PLANNING AND ZONING BOARD MEETING

Re: New Business Items Planning and Zoning Meeting December 13, 2021

1. Mecato's Bakery and Café - Site Plan Review, Waivers and Variance Applications 5645 Hansel Avenue

Drive-up Window Location and Queue Lane

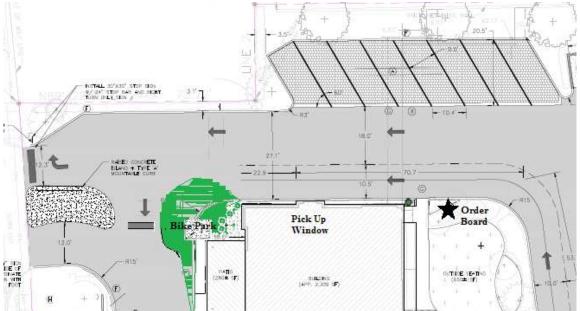
The applicant is requesting a waiver from Code Section 134-472(b), which requires drive-up windows to be designed on the rear of the building and to incorporate a drive up lane of a minimum of 120 feet in length as measured from the first stopping point; e.g., the order board. Due to using an existing building, the most practical location for a pick up window from the internal bakery floor plan perspective is on the north side. It would be impractical to locate the window in the rear. Staff can support this location with a condition for redesign of the front elevation with a faux wall or landscaping to "hide" the window from Hansel Avenue (see illustration).

Staff supports approval with the condition of screening the drive through lane/window from Hansel Avenue. The condition will help to,

Action Needed: Redesign to screen the drive through lane/window from Hansel Avenue.

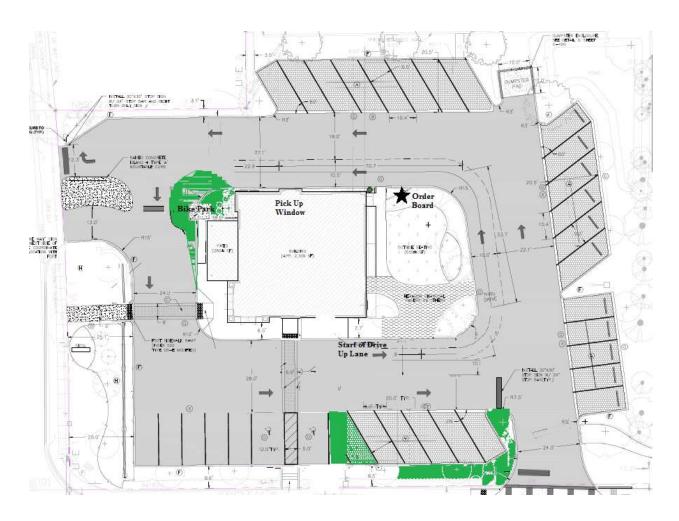
The second waiver related to the drive-up window is the queue length. The menu board/order location is not identified on the site plan, however is identified on the landscape plan. The proposed queue at the order board is 57 feet, only accommodating the ordering vehicle and one waiting. Code requires 120 feet, accommodating one at the order board and five waiting. The queue length can be increased by moving the order board to the west and using the northern 10.5 feet of part of the east/west drive aisle (after conversion to one-way) as illustrated on the next page. No parking spaces are lost in this alternative design.

In addition, an increase in queue length is recommended by moving the order/menu board five feet east of the sidewalk from the outdoor patio to the north parking area. Staff recommends provision of a cross walk and adding pavement striping to delineate the drive through lane staff recommends approval. This will help to serve the health, safety and welfare of the city.

Drive-up Window Location and Queue Lane

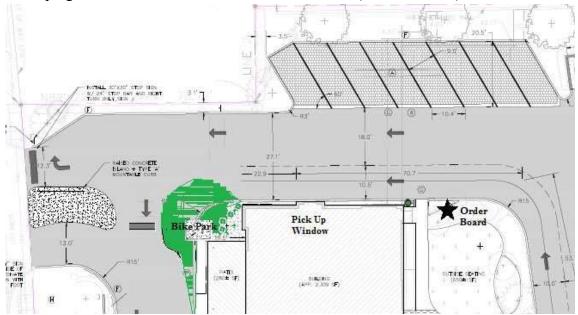
The applicant is requesting a waiver from Code Section 134-472(b), which requires drive-up windows to be designed on the rear of the building and to incorporate a drive up lane of a minimum of 120 feet in length as measured from the first stopping point; e.g., the order board. Due to using an existing building, the most practical location for a pick up window from the internal bakery floor plan perspective is on the north side. It would be impractical to locate the window in the rear. Staff can support this location with a condition for redesign of the front elevation with a faux wall or landscaping to "hide" the window from Hansel Avenue (see illustration).

Staff supports approval with the condition of screening the drive through lane/window from Hansel Avenue. The condition will help to,

Action Needed: Redesign to screen the drive through lane/window from Hansel Avenue. (Not accepted)

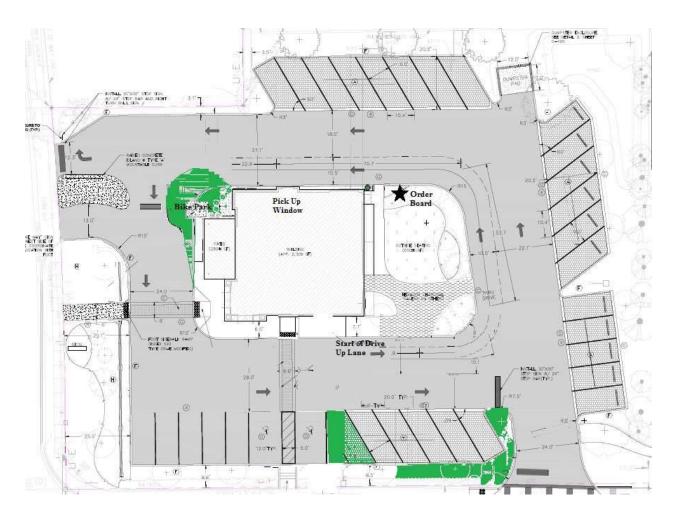
The second waiver related to the drive-up window is the queue length. The menu board/order location is not identified on the site plan, however is identified on the landscape plan. The proposed queue at the order board is 57 feet, only accommodating the ordering vehicle and one waiting. Code requires 120 feet, accommodating one at the order board and five waiting. The queue length can be increased by moving the order board to the west and using the northern 10.5 feet of part of the east/west drive aisle (after conversion to one-way) as illustrated on the next page. No parking spaces are lost in this alternative design.

In addition, an increase in queue length is recommended by moving the order/menu board five feet east of the sidewalk from the outdoor patio to the north parking area. Staff recommends provision of a cross walk and adding pavement striping to delineate the drive through lane staff recommends approval. This will help to serve the health, safety and welfare of the city.

Drive-up Window Location and Queue Lane

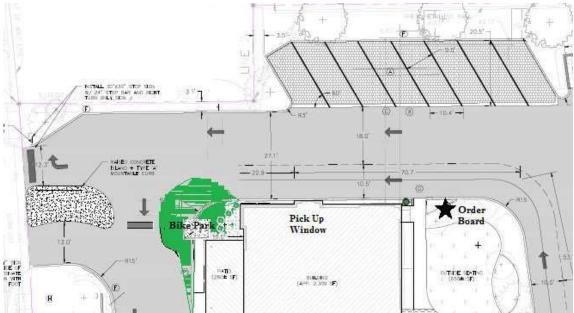
The applicant is requesting a waiver from Code Section 134-472(b), which requires drive-up windows to be designed on the rear of the building and to incorporate a drive up lane of a minimum of 120 feet in length as measured from the first stopping point; e.g., the order board. Due to using an existing building, the most practical location for a pick up window from the internal bakery floor plan perspective is on the north side. It would be impractical to locate the window in the rear. Staff can support this location with a condition for redesign of the front elevation with a faux wall or landscaping to "hide" the window from Hansel Avenue (see illustration).

Staff supports approval with the condition of screening the drive through lane/window from Hansel Avenue. The condition will help to,

Action Needed: Redesign to screen the drive through lane/window from Hansel Avenue. (Not accepted)

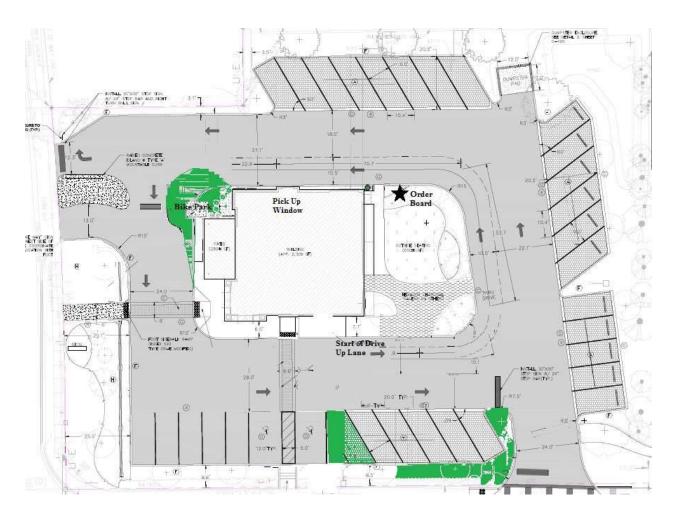
The second waiver related to the drive-up window is the queue length. The menu board/order location is not identified on the site plan, however is identified on the landscape plan. The proposed queue at the order board is 57 feet, only accommodating the ordering vehicle and one waiting. Code requires 120 feet, accommodating one at the order board and five waiting. The queue length can be increased by moving the order board to the west and using the northern 10.5 feet of part of the east/west drive aisle (after conversion to one-way) as illustrated on the next page. No parking spaces are lost in this alternative design.

In addition, an increase in queue length is recommended by moving the order/menu board five feet east of the sidewalk from the outdoor patio to the north parking area. Staff recommends provision of a cross walk and adding pavement striping to delineate the drive through lane staff recommends approval. This will help to serve the health, safety and welfare of the city.

C - 000

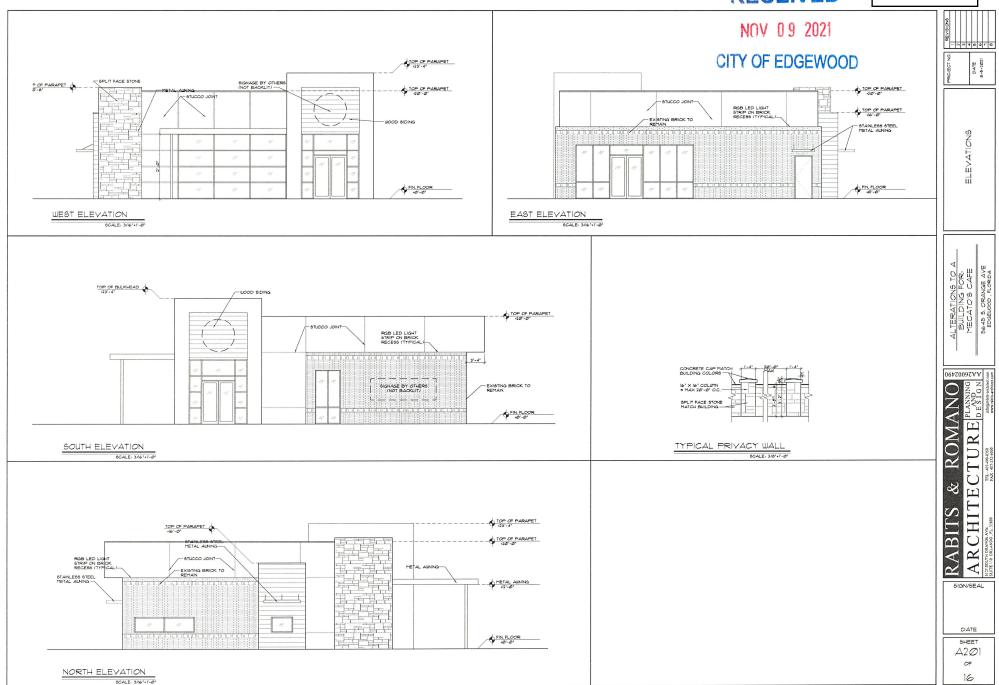
- Sheet C-000 Update the reference to contact Sunshine One Call for utility locates. Need
 to add the Sunshine logo to the plans reference to call at least two full business days in
 advance for locates. This notification will be on the Sunshine logo and is downloadable
 from their website.

- 2. Sheet C-000 The total impervious area does not include the building area for both predevelopment and post-development.
- 3. Sheet C-002 was not provided.

1. Sheet C-000. - Update the reference to contact Sunshine One Call for utility locates. Need to add the Sunshine logo to the plans reference to call at least two full business days in advance for locates. This notification will be on the Sunshine logo and is downloadable from their website. (Accepted)

2. Sheet C-000. - The total impervious area does not include the building area for both predevelopment and post-development. (Accepted)

Action Taken: complied see sheet C-000.

Action Taken: complied see sheet C-000.
